# ADMINISTRATIVE AMENDMENT

ADMINISTRATIVE  
DEVELOPMENT PLAN AMENDMENT  
**FILE NO. 7-1065-1**  
*Spicelite Building*  
*+ Revised Landscaping Plan*  
*By: [Signature]* 2-2-89  
PLANNING DIRECTOR DATE

**LIZARD TAIL  
 BREWING  
 REMODEL**

**PARADISE  
 SQUARE**

**NEW SITE DEVELOPMENT PLAN  
SITE PLAN**  
SCALE 1" = 30'

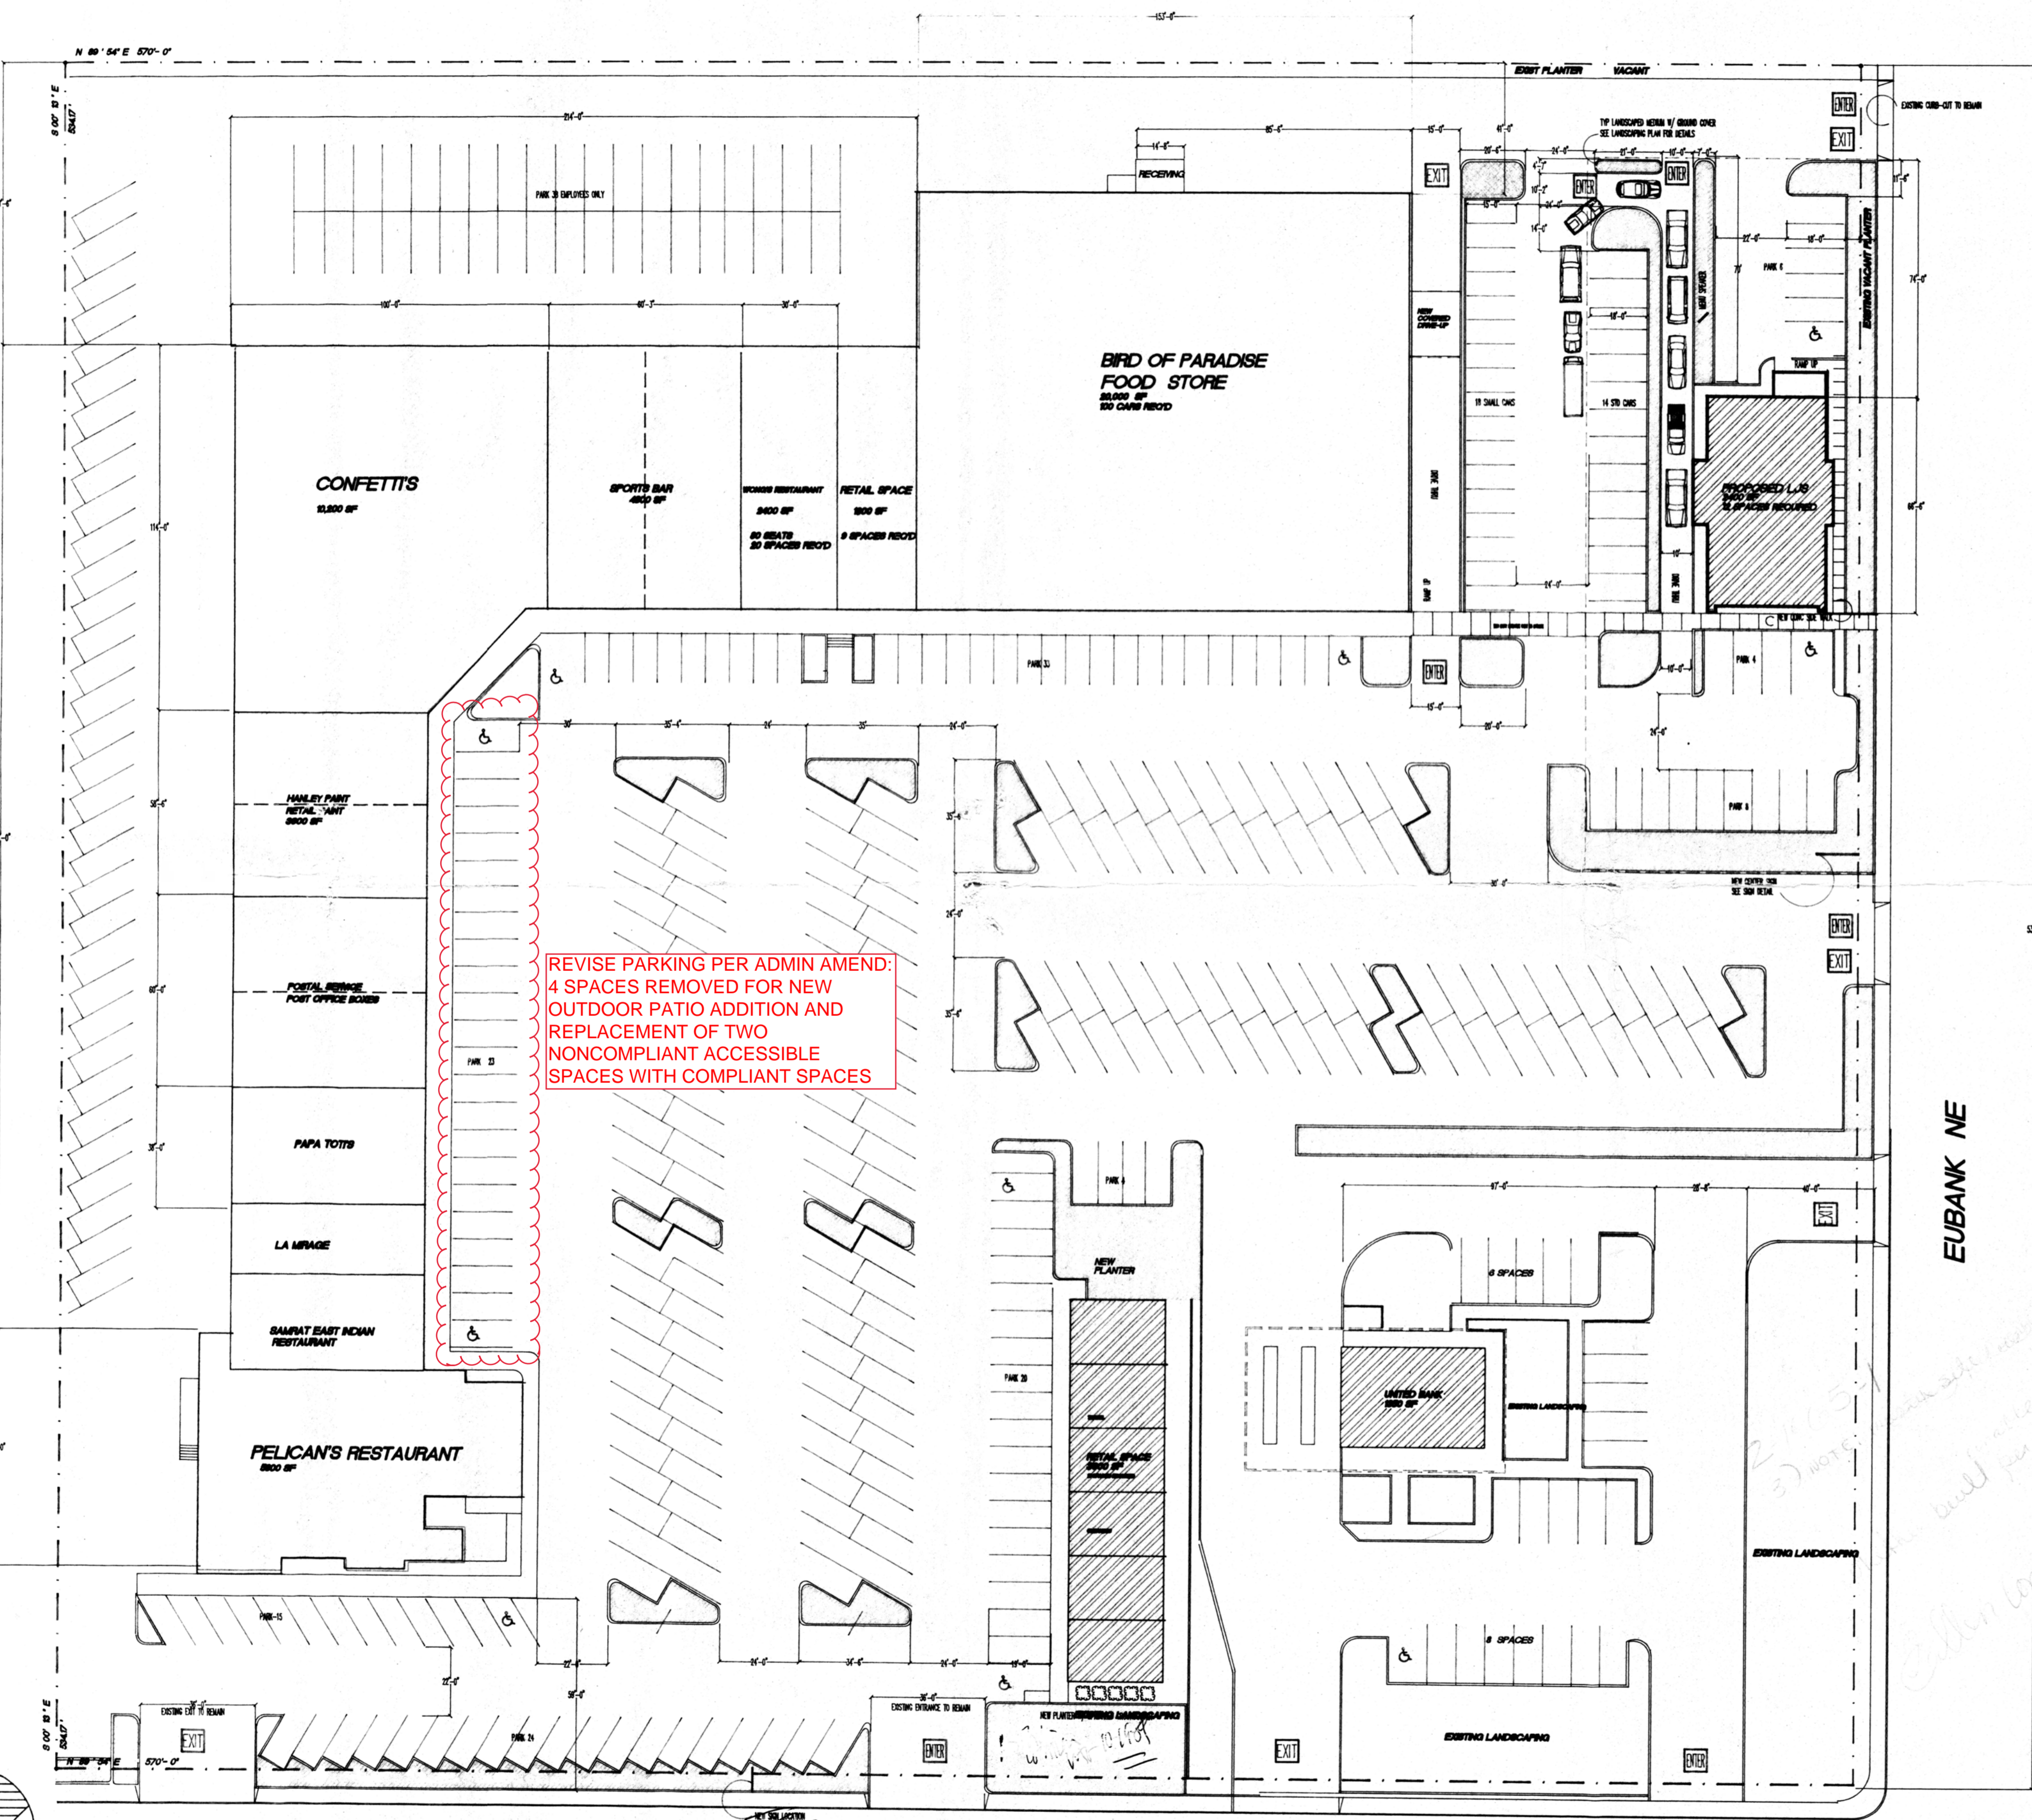
REVISE PARKING PER ADMIN AMEND:  
4 SPACES REMOVED FOR NEW  
OUTDOOR PATIO ADDITION AND  
REPLACEMENT OF TWO  
NONCOMPLIANT ACCESSIBLE  
SPACES WITH COMPLIANT SPACES

392-096 SPACES PROVIDED  
PARKING ALLOTMENT  
215 STANDARD SPACES  
100 SMALL CARS  
72 EMPLOYEE ONLY  
10 HANDICAPPED  
% OF PARKING PROVIDED AT 116%

377 SPACES REQUIRED  
10% REDUCTION FOR BUS STOP  
340 REVISED REQ'D PARKING

**REVISSED SITE PLAN**

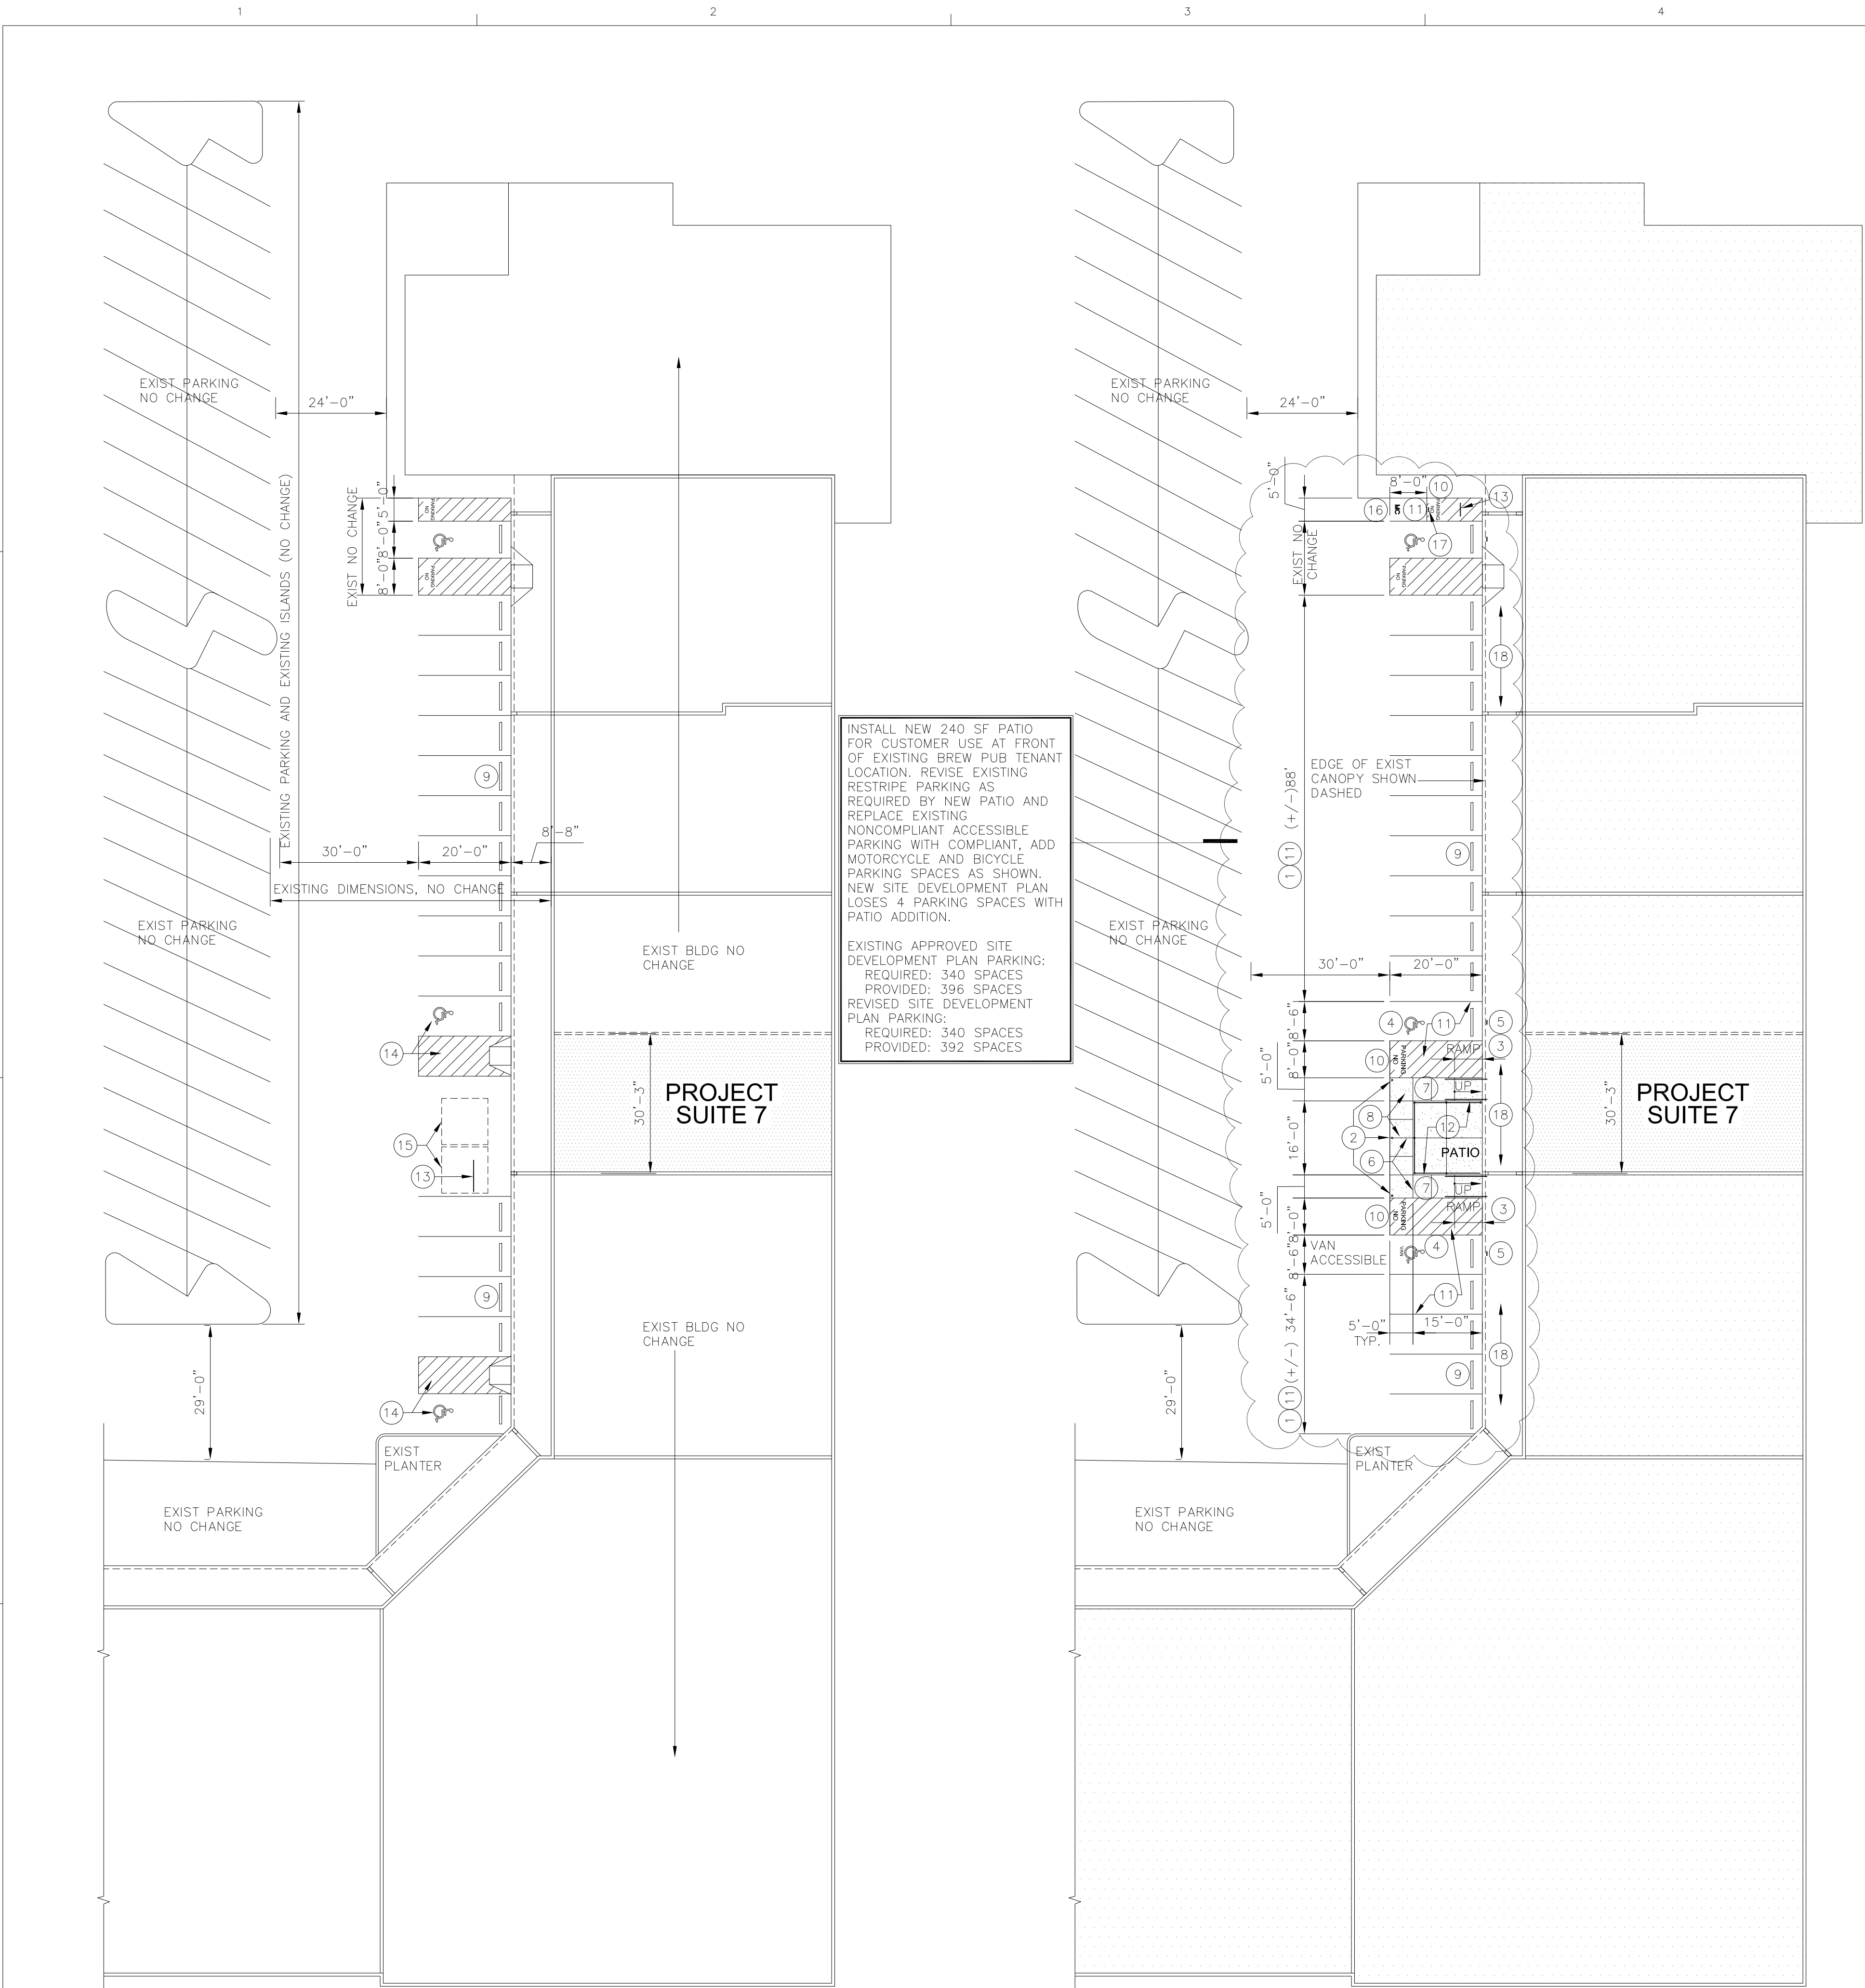
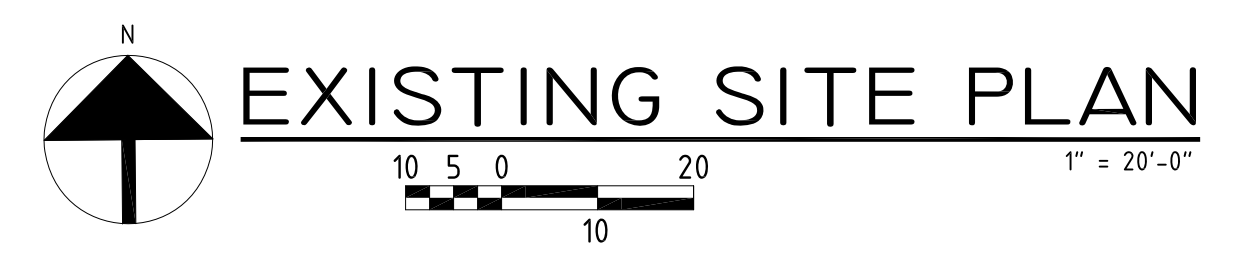
INSTALL NEW 240 SF PATIO FOR CUSTOMER USE AT FRONT OF EXISTING BREW PUB TENANT LOCATION. REVISE EXISTING RESTRIPE PARKING AS REQUIRED BY NEW PATIO AND REPLACE EXISTING NONCOMPLIANT ACCESSIBLE PARKING WITH COMPLIANT, ADD MOTORCYCLE AND BICYCLE PARKING SPACES AS SHOWN. NEW SITE DEVELOPMENT PLAN LOSES 4 PARKING SPACES WITH PATIO ADDITION.

EXISTING APPROVED SITE DEVELOPMENT PLAN PARKING:  
 REQUIRED: 340 SPACES  
 PROVIDED: 396 SPACES

REVISED SITE DEVELOPMENT PLAN PARKING:  
 REQUIRED: 340 SPACES  
 PROVIDED: 392 SPACES
